Arizona Department of Transportation

MEMORANDUM

Subject: C-Standards Update

Construction Standard Drawings Revisions – April 2006

APPROVED FOR DESIGN <i>May Viparina</i>	STATE OF ARIZONA DEPARTMENT OF TRANSPORTATION ROADWAY STANDARD DRAWINGS	REV. 4/06
APPROVED FOR DISTRIBUTION <i>Julio</i>	SLOPES RURAL UNDIVIDED AND FRINGE-URBAN HIGHWAYS	DRAWING NO. C-02.20

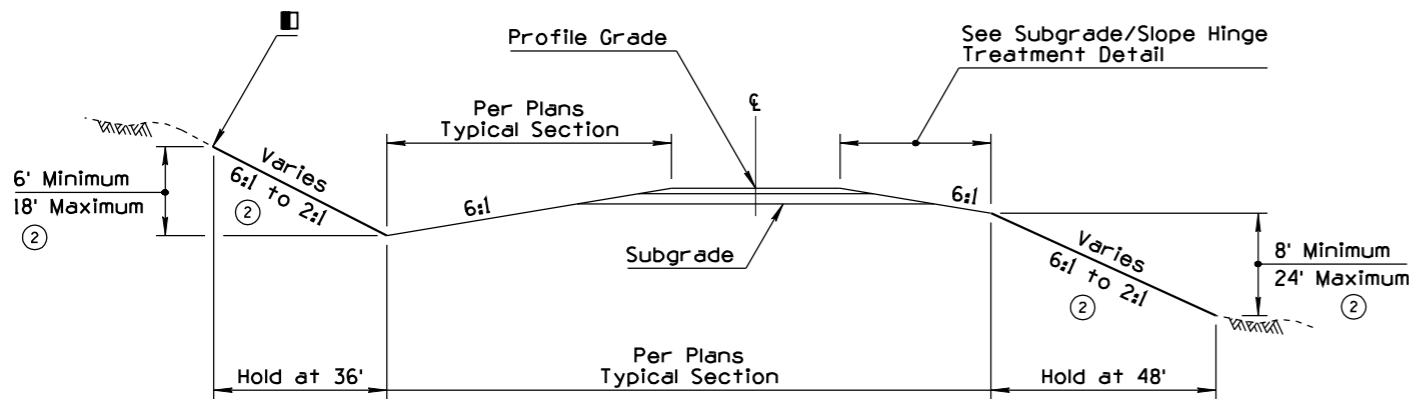
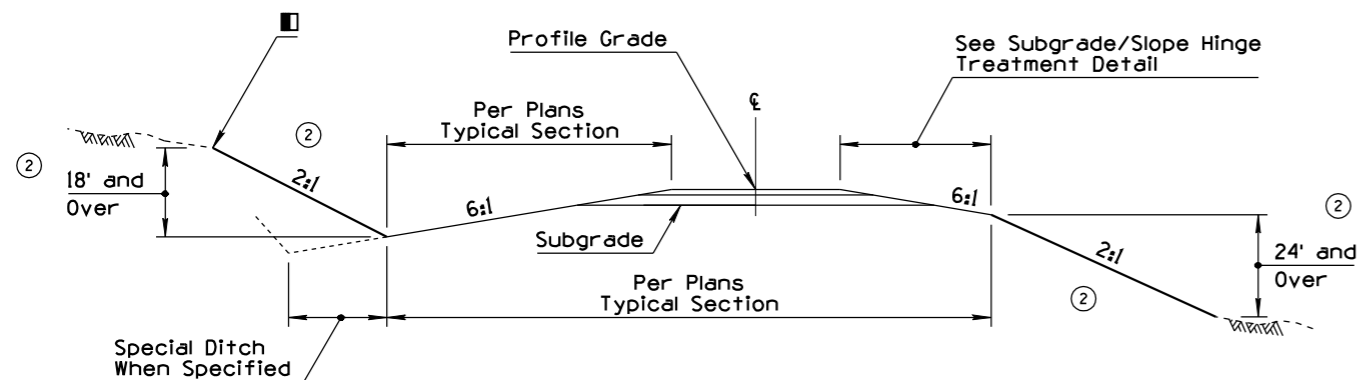
Please refer to the updated Construction Standard Drawings (Rev.date 4/06) that were issued today under separate e-mail notification. The maximum fill slope rates for Std. C-02.20 Rural Undivided and Fringe-Urban Highways and Std. C-02.30 Miscellaneous Roadways have been revised from 1 1/2:1 to 2:1. Also, the maximum cut slope rates for these two standards have been revised from 1:1 to 2:1. No slope changes have been made to Std. C-02.10 Rural Divided Highways. These revisions have been coordinated with the Materials Group Geotechnical Design.

The revisions to the slopes reflect what has been the norm for most projects. The 2:1 fill slopes provide a more stable embankment and provide an improved slope rate to establish vegetation and erosion control. The flatter 2:1 cut slope rates will also provide the same advantages. When in rock cuts, Geotechnical Design will continue to provide the maximum slope that can be used by the designer. Also, when cuts are in the higher ranges and there may be a significant project cost involved, Geotechnical Design will provide the designer the maximum slope that can be used to reduce the excavation required. The design process for establishing slope design for a project has not changed. The standard slopes simply provide the initial design slopes and the designer is to adjust the slopes for the project needs considering safety, material type, project costs, slope stabilization and other needs.

NO	DESCRIPTION OF REVISIONS	MADE BY	DATE
1	REVISED TITLE	RLF	4/06
2	MODIFIED SLOPE CRITERIA	RLF	4/06
3			
4

APPROVED FOR DESIGN <i>May Vipavina</i>	STATE OF ARIZONA DEPARTMENT OF TRANSPORTATION ROADWAY STANDARD DRAWINGS	REV. 4/06
APPROVED FOR DISTRIBUTION <i>Julio</i>	SLOPES MISCELLANEOUS ROADWAYS	DRAWING NO. C-02.30

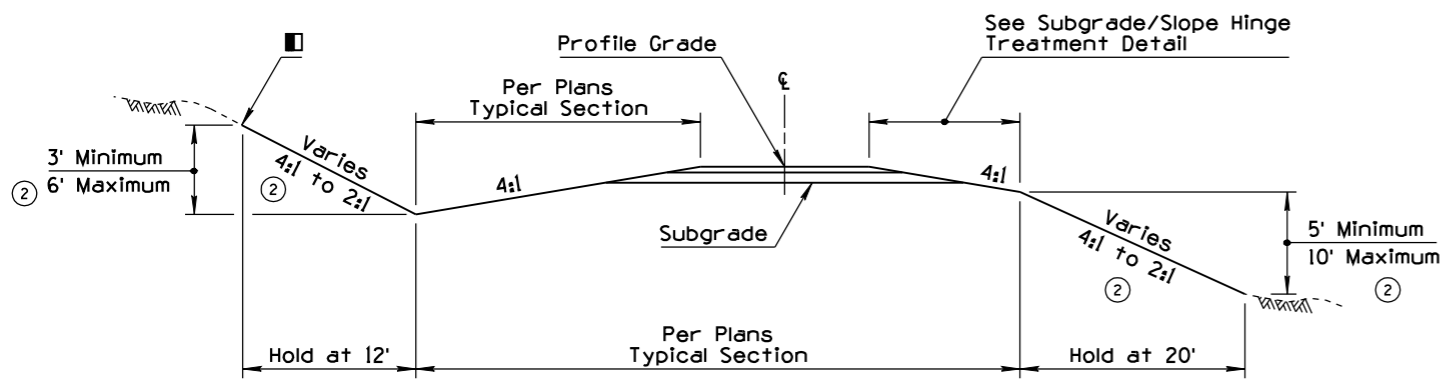
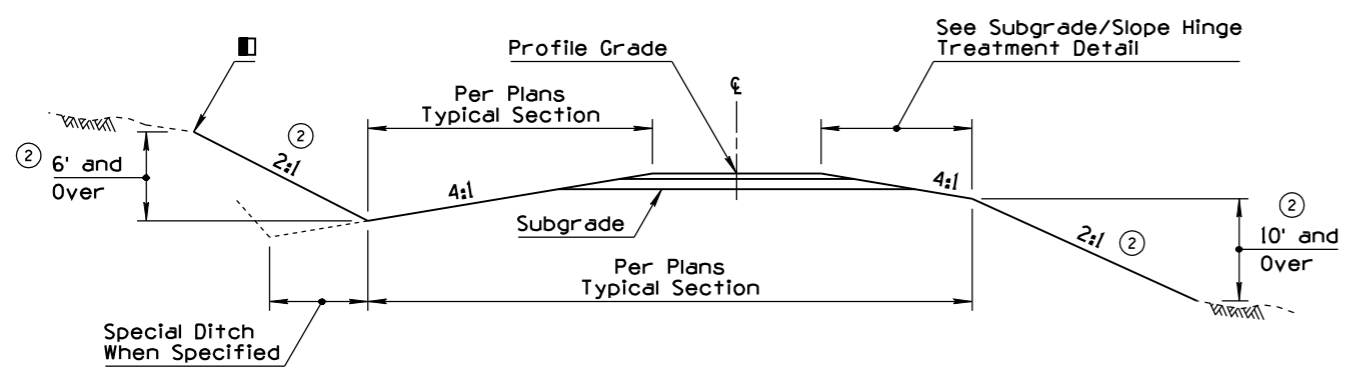
NO	DESCRIPTION OF REVISIONS	MADE BY	DATE
1	MODIFIED TITLE	RLF	4/06
2	MODIFIED SLOPE CRITERIA	RLF	4/06
3	ADDED USAGE NOTE	RLF	4/06
4

APPROVED FOR DESIGN <i>Mary Viparina</i>	STATE OF ARIZONA DEPARTMENT OF TRANSPORTATION ROADWAY STANDARD DRAWINGS	REV. 4/06
APPROVED FOR DISTRIBUTION <i>John [Signature]</i>	SIDEWALK RAMP TYPE C	DRAWING NO. ① C-05.30 Sheet 3 of 7

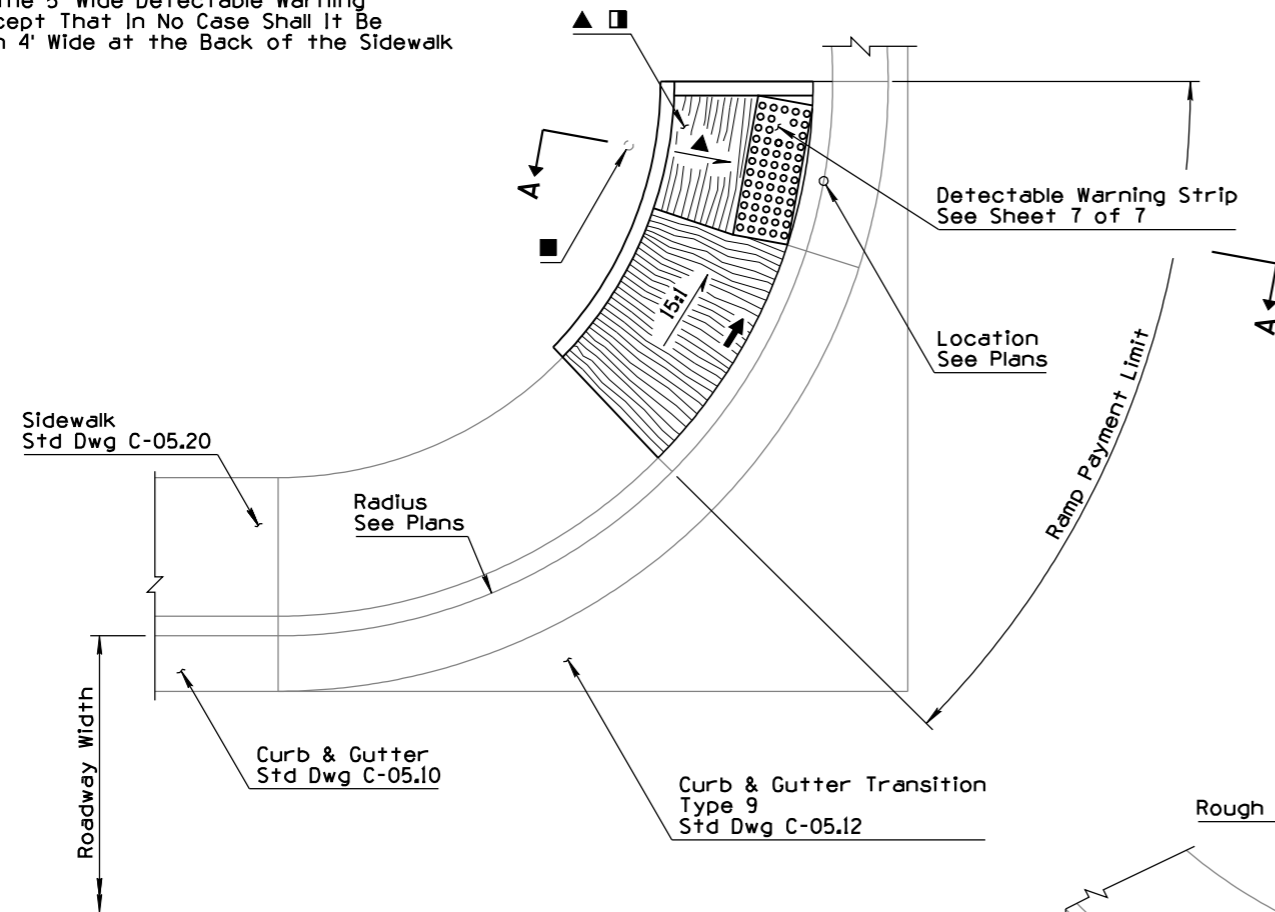
- C-02.20 & C-02.30: Revised cut and fill slope dimensions;
- C-05.30, Shts 3 & 4 of 7: Modified PLAN and PERSPECTIVE views to clarify ramp location;
- C-05.30, Sht 7 of 7: Added a PLAN and SECTION views for a brick detectable warning strip;
- C-10.76: Modified SECTION views to depict "F" shape; and
- C-11.10: Re-issued the drawings in four sheets. Sheet 4 shows the clamp designed to enhance the bicycle ridability of the cattle guard.

APPROVED FOR DESIGN <i>May Vipawina</i>	STATE OF ARIZONA DEPARTMENT OF TRANSPORTATION ROADWAY STANDARD DRAWINGS	REV. 4/06
APPROVED FOR DISTRIBUTION <i>Julio</i>	SIDEWALK RAMP TYPE D	DRAWING NO. ① C-05.30 Sheet 4 of 7

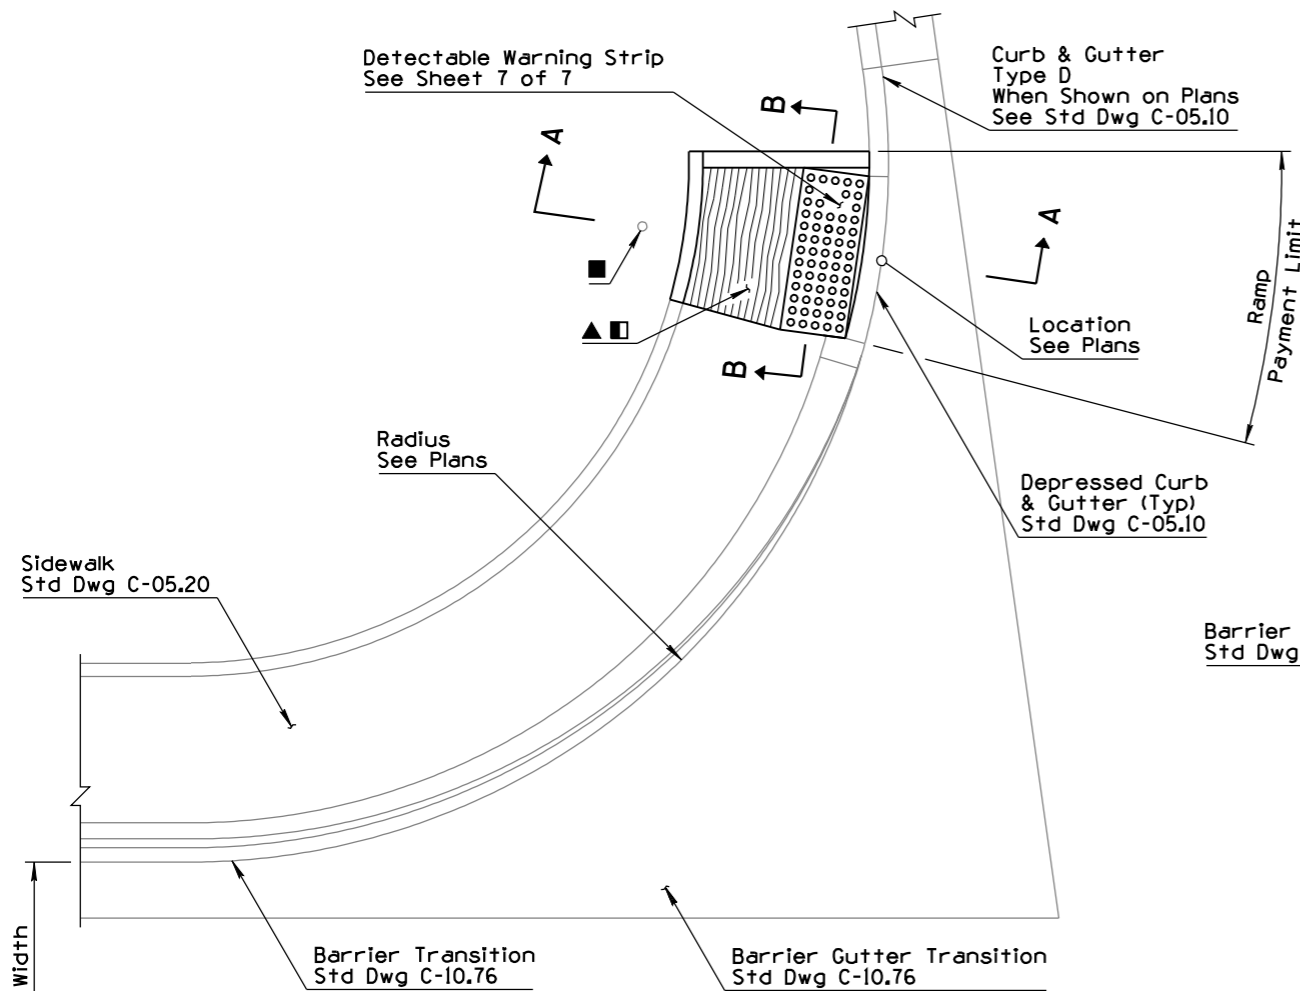
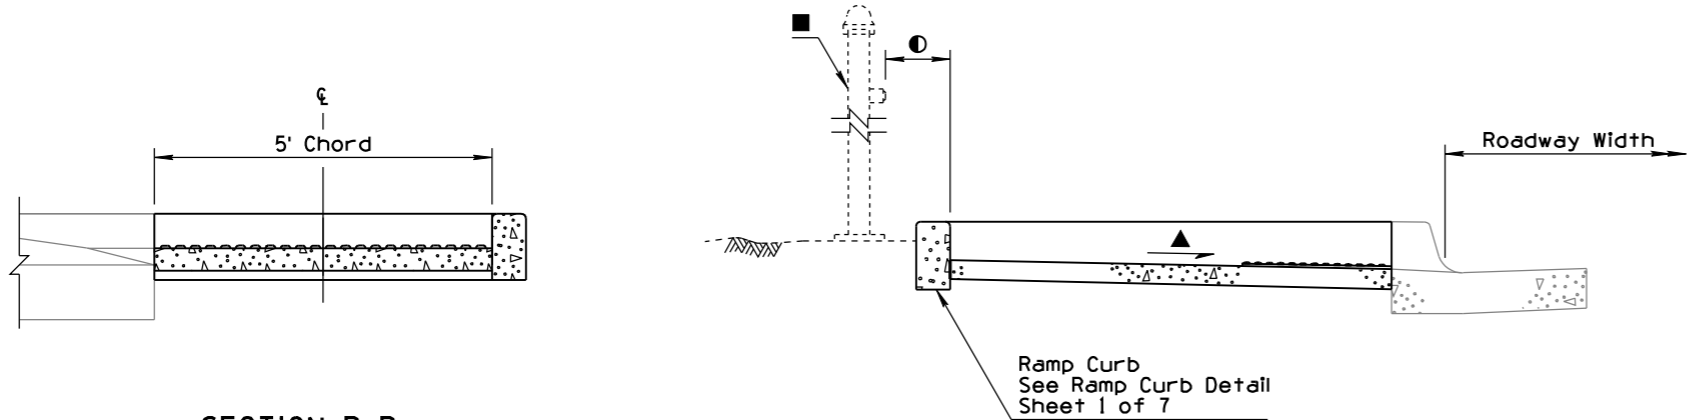
C-05.30, Sheet 4 of 7	Modified ramp location in PLAN and PERSPECTIVE views.
C-05.30, Sheet 5 of 7	Modified General Note 3.
C-05.30, Sheet 7 of 7	Added PLAN and SECTION views of brick option Detectable Warning Strip (DWS). Modified PLAN view of non-brick DWS. Added General Note 1. Re-labeled section and detail views.
C-05.50	Revised General Note 6. Rearranged drawings on sheet. Modified SECTION A--A. Revised Std Dwg reference in SECTION C--C. Re-labeled "PLAN VIEW OF SECTION C--C".
C-07.02	Revised General Notes 3 & 4 to correct Std Dwg reference from C-07.05 to C-07.04. Revised drawing titles.
C-10.51	Changed "PLAN VIEW" to "PLAN". Removed slope designation from sidewalk in SECTION views. Changed length of vertical taper from 12½" to 1'-0". Revised text orientation. Added "WITHOUT GUARDRAIL" to title of ELEVATION view of departure vertical taper.
C-10.52	Removed "D" reference and substituted "may" for "can" in General Note 5.

APPROVED FOR DESIGN <i>May Vipawina</i>	STATE OF ARIZONA DEPARTMENT OF TRANSPORTATION ROADWAY STANDARD DRAWINGS	REV. 4/06
APPROVED FOR DISTRIBUTION <i>Julio</i>	SIDEWALK RAMP DETECTABLE WARNING STRIP	DRAWING NO. C-05.30 Sheet 7 of 7

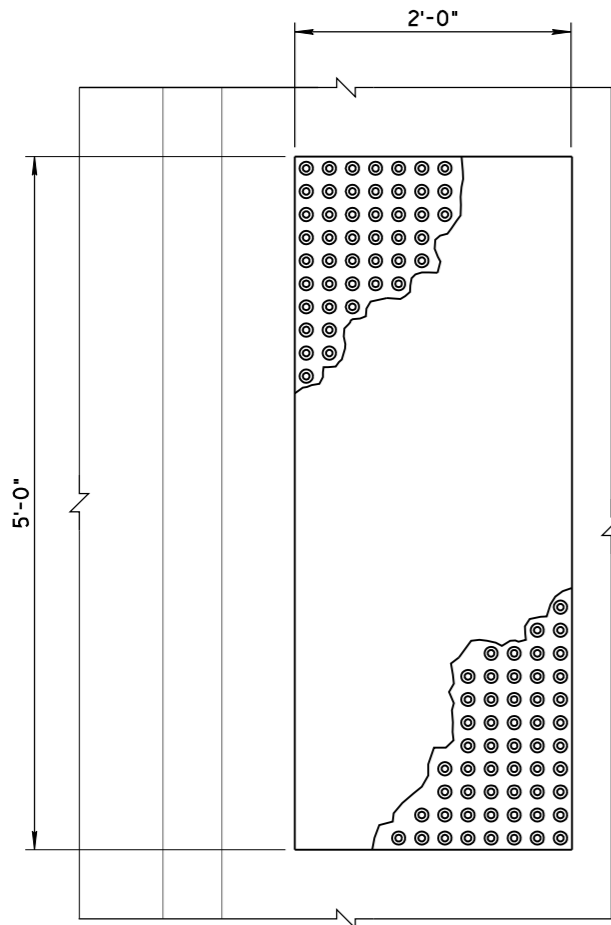
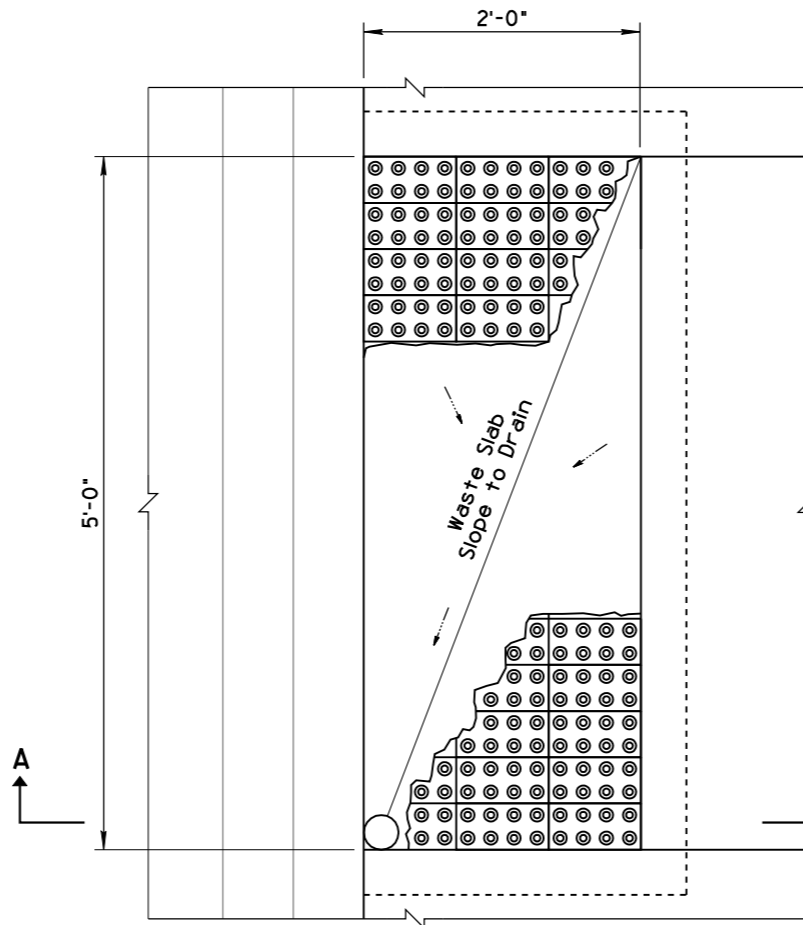
NO	DESCRIPTION OF REVISIONS	MADE BY	DATE
1	ADDED PLAN & SECTION FOR BRICK OPTION	RLF	4/06
2	REVISED TITLE	RLF	4/06
3			
4

APPROVED FOR DESIGN <i>Mary Viparina</i>	STATE OF ARIZONA DEPARTMENT OF TRANSPORTATION ROADWAY STANDARD DRAWINGS	REV. 4/06
APPROVED FOR DISTRIBUTION <i>John [Signature]</i>	CONCRETE HALF-BARRIER TRANSITION TYPE 'F' TANGENT DEPARTURE TYPE 1	DRAWING NO. C-10.75 Sheet 1 of 2

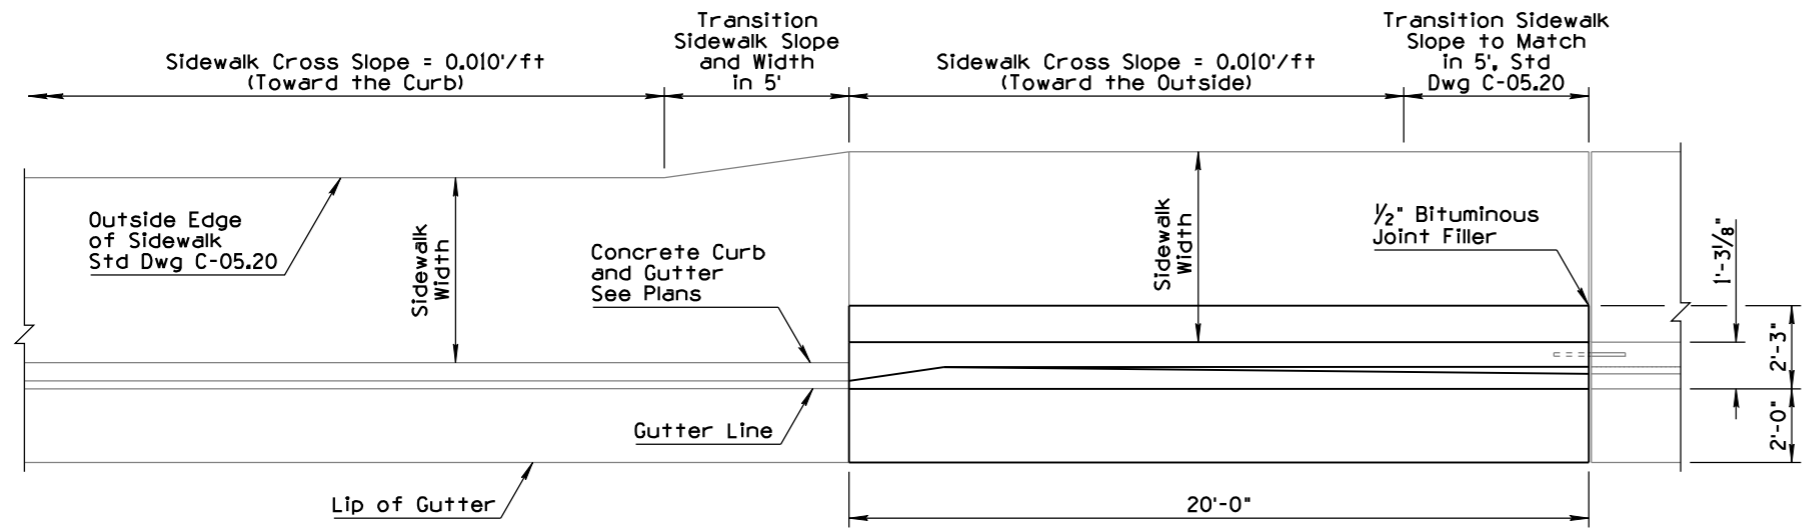
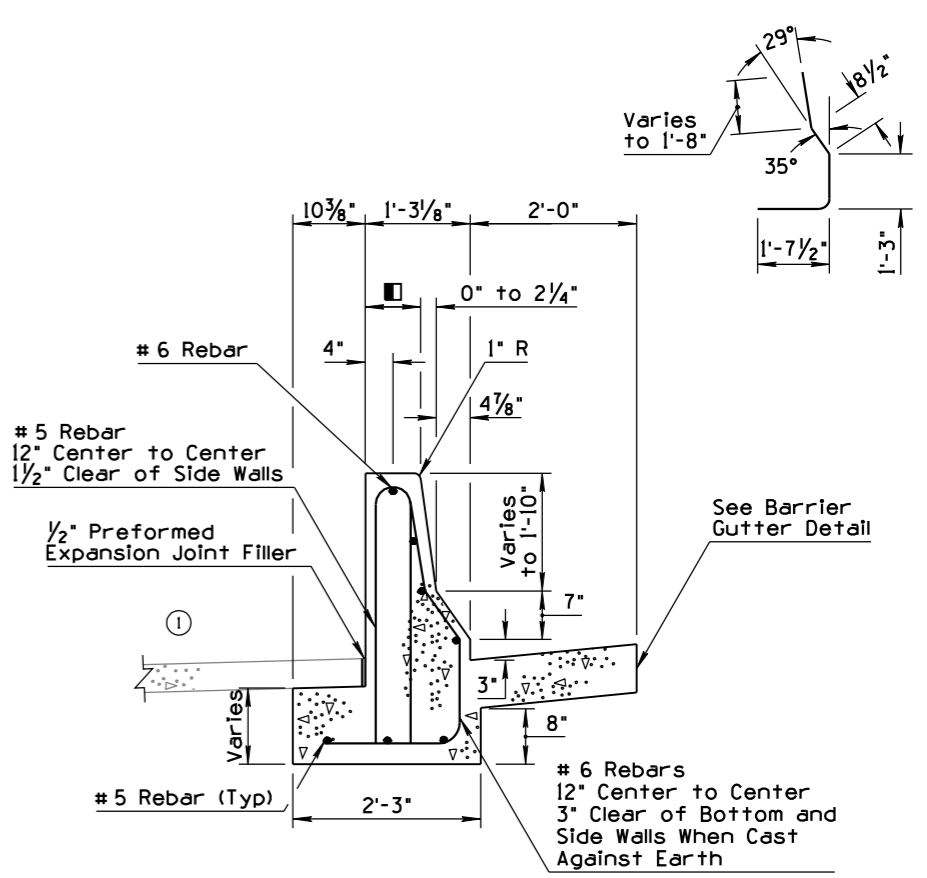
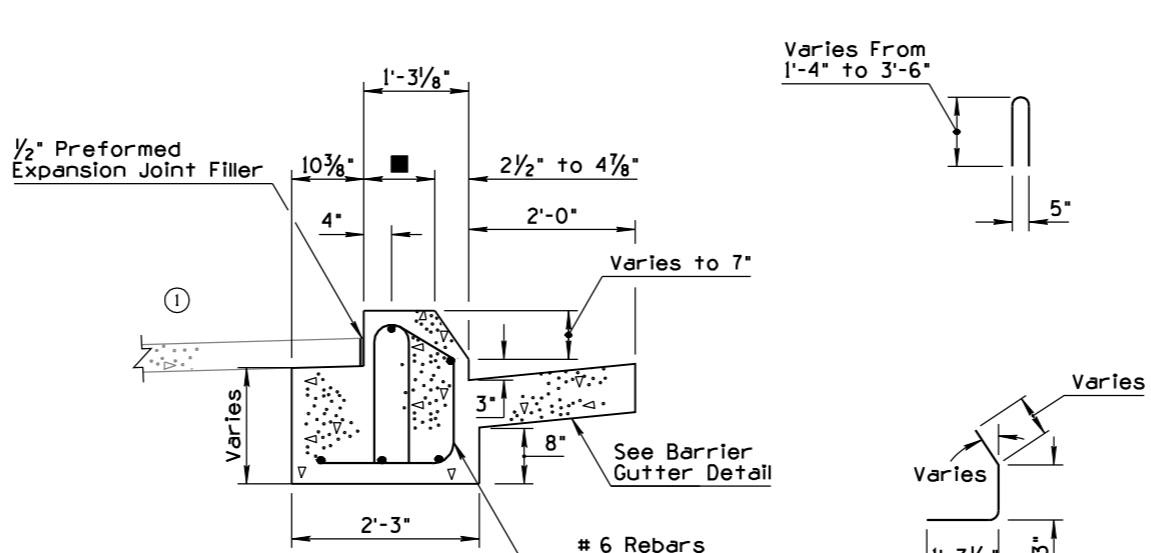
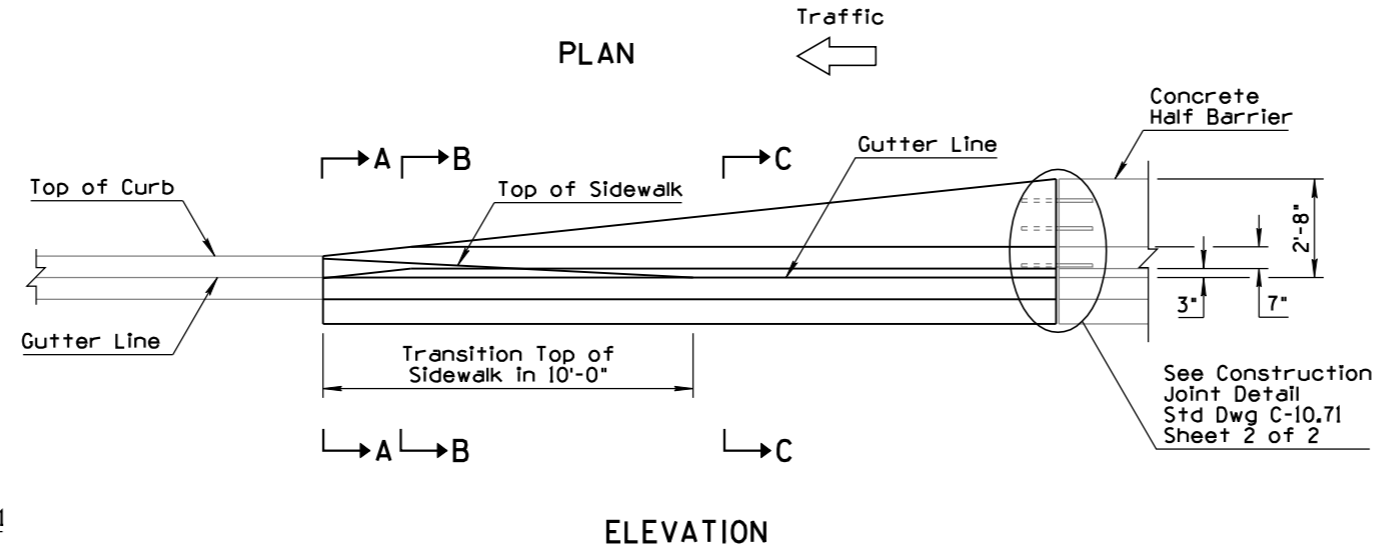
C-10.75, Sheet 1 of 2	Changed "PLAN VIEW" to "PLAN". Removed slope designation from sidewalk in SECTION views. Revised curb-height designation in SECTION A-A from "H" to "h".
C-10.75, Sheet 2 of 2	Changed "PLAN VIEW" to "PLAN". Removed dimensions at right side of PLAN view. Revised text orientation.
C-10.76	Changed "PLAN VIEW" to "PLAN". Revised SECTION view graphics to depict Type 'F' barrier.
C-10.77	Modified PLAN view to correct style and proportion of concrete half barrier and transitions. Modified references to other Std Dwgs.
C-11.10 Sheets 1 through 4 of 4	Re-issued Standard Drawing.
C-15.20, Sheet 1 of 3	Revised sheet number references.
C-15.91 & C-15.92, Sheet 2 of 2	Modified welding notations for ANSI conformance.
C-18.10, Sheet 2 of 3	Modified SECTION views to improve clarity.

NO	DESCRIPTION OF REVISIONS	MADE BY	DATE
1	REVISED SECTION VIEW GRAPHICS	RLF	4/06
2	REVISED 'H' HEIGHT DESIGNATION TO 'h'	RLF	4/06
3			
4
